## 24 Wandeen Rd 455 response to RFI and submission summery.

### Response to NBC RFI

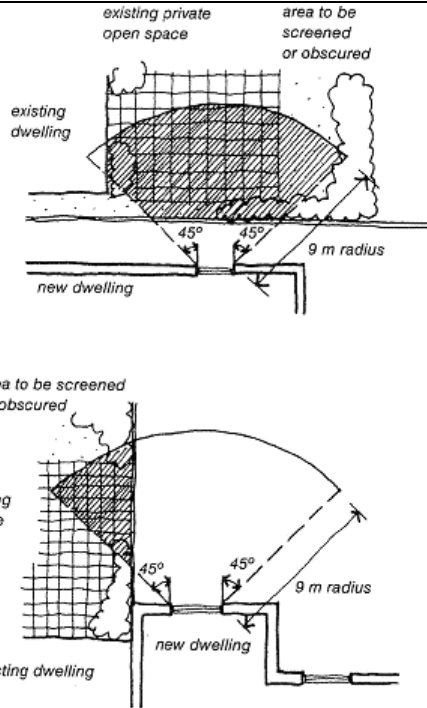
RFI Item	Plans to be referred to	
Clause 4.3 Height of Buildings 1. Non compliance to 8.5m height	RFI Plans 104.1 – 105.5	<p>Variation to control D1.11 approved and applied by NBC as site is more than 30% gradient. In the location of the modified area the land is in excess of 40%.</p> <p><b>Additional comments</b></p> <ul style="list-style-type: none"> <li>- Modified area is still lower than the max heights of other areas of the building</li> <li>- The increased areas provide view corridors of the pitt water over neighbouring with no privacy impacts, additional over shadowing to POS</li> <li>-NBC cannot deprive the dwelling of the views for a reason that has no impacts to neighbouring properties and the street</li> <li>- The modified area from street view aspects (105.1, 105.2) is almost not visible due to the established protected trees and topography of the site.</li> <li>- The modified area cannot be seen from a neighbouring property, its also screen by established trees on the western boundary</li> </ul> <p>View sharing (Clause C1.3) All new development is to be designed to achieve a reasonable sharing of views available from surrounding and nearby properties. The proposal must demonstrate that view sharing is achieved through the application of the Land and Environment Court's planning principles for view sharing</p> <p><i>Proposal meets all controls, there for NBC and LPP has no grounds for refusal</i></p>
